ACCESSION NBR: 9710230092 DOC. DATE: 97/10/20 NOTARIZED: YES DOCKET #
 FACIL: 50-244 Robert Emmet Ginna Nuclear Plant, Unit 1, Rochester G 05000244
 AUTH. NAME AUTHOR AFFILIATION
 MECREY, R.C. Rochester Gas & Electric Corp.
 RECIP. NAME RECIPIENT AFFILIATION
 VISSING, G.S.

SUBJECT: Forwards non-proprietary & proprietary response to 970905
 RAI re structural evaluation of proposed mod of plant spent
 fuel storage pool, dtd 970331. Proprietary response withheld,
 per 10CFR2.790.

Subject: Response to Request for Additional Information - Spent Fuel Pool (SFP) Modifications - Structural Design Considerations (TAC No. M95759)
R.E. Ginna Nuclear Power Plant
Docket No. 50-244

Figure NRCO1a.1 **Design Vs Input For GINNA SSE1 - Horizontal X**

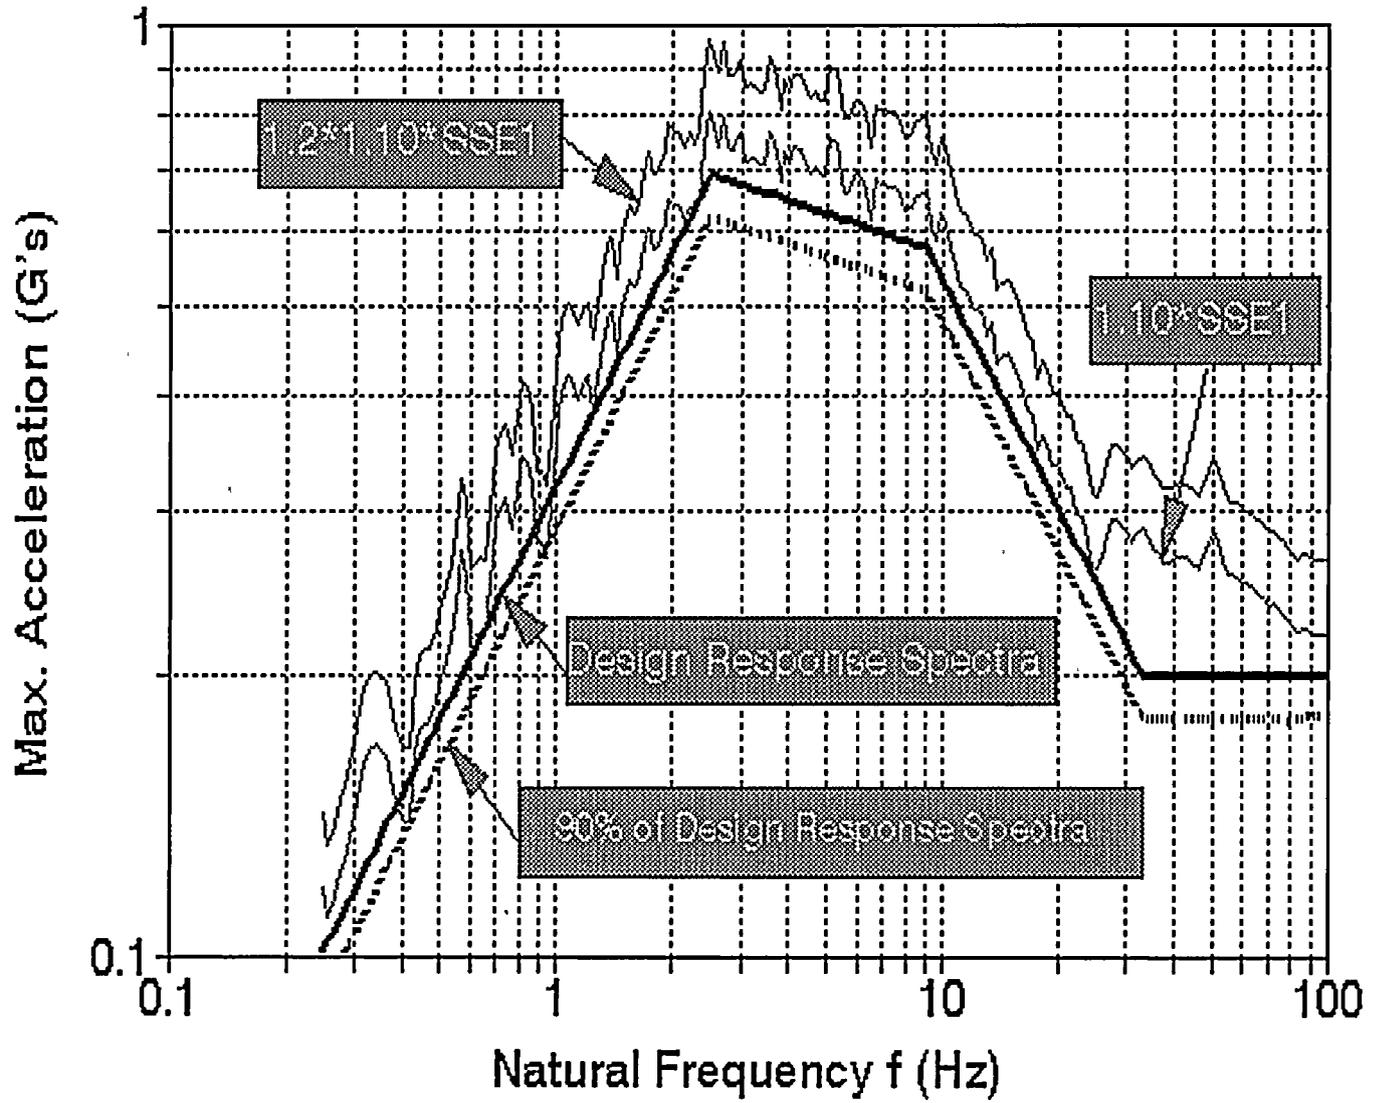
- a) *A comparison between the response spectrum (RS) of the artificial time history and the licensing basis design RS in the final safety analysis report (FSAR).*
- b) *Demonstrate the adequacy of the artificial time history including a demonstration of the extent of conformance to a target power spectral density (PSD) function of the artificial time history in accordance with guidance provided in Standard Review Plan (SRP) Section 3.7.1.*
- c) *If the RS of the artificial time history does not envelope the licensing basis design RS in the FSAR, what is the basis for using it in the analysis?*

- a) A comparison of the fuel pool safe shutdown earthquake (SSE) response spectra and the response spectra generated from the SSE1 time history used in the seismic analysis is provided in Figures NRCQ1a.1, NRCQ1a.2 and NRCQ1a.3. NUREG-800, SRP 3.7.1, Section II.1.b states "Each calculated spectrum of the artificial time history is considered to envelop the design response spectrum when no more than five points fall below, and no more than 10 percent below, the design response spectrum." For this comparison, the 10% below curve is also plotted in Figures NRCQ1a.1, NRCQ1a.2 and NRCQ1a.3. The comparison shows:

East-West (X) Spectra	2 frequencies below design RS but within 10% threshold
North-South (Y) Spectra	2 frequencies below design RS but within 10% threshold
Vertical (Z) Spectra	1 frequency below design RS but within 10% threshold

Figure A1 Experiment Setup

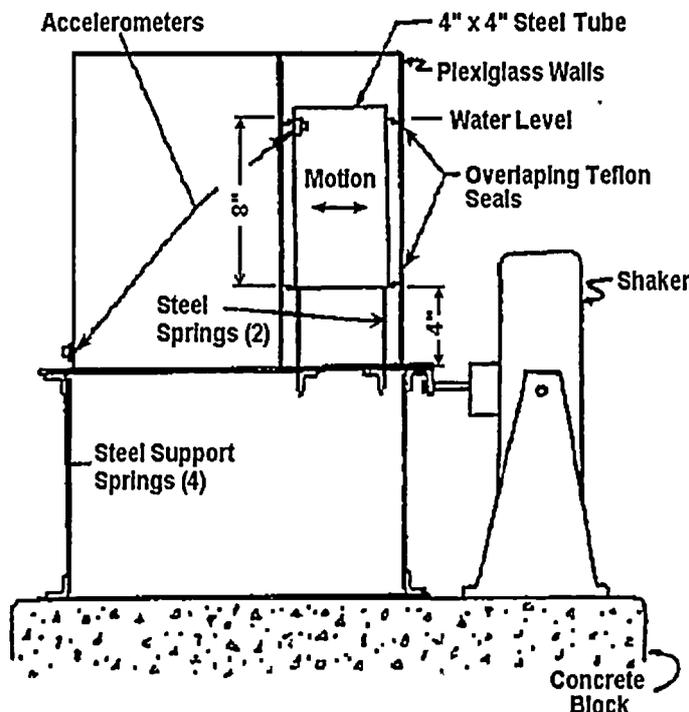
- b) *Provide the results of any existing experimental study that verifies the correct or adequate simulation of the fluid coupling utilized in the numeric analyses for the fuel assemblies, racks and walls. If there is no such experimental study available, provide in detail technical justifications on how the current level of the ANSYS code verification is adequate for engineering applications and should be accepted without further experimental verification work.*

An experimental set-up, reported in References 3.45 and 3.46, is shown in Figure A1. A rectangular steel tube with a solid bottom is enclosed in a long rectangular plexiglass container rigidly connected to a solid base plate. The base plate is supported with four steel consoles acting as springs for the laterally imposed base plate motion via electromagnetic actuator. The plexiglass container is additionally reinforced with a separate rectangular plexiglass plate fixed to the base plate (Fig.A1, left upper corner).
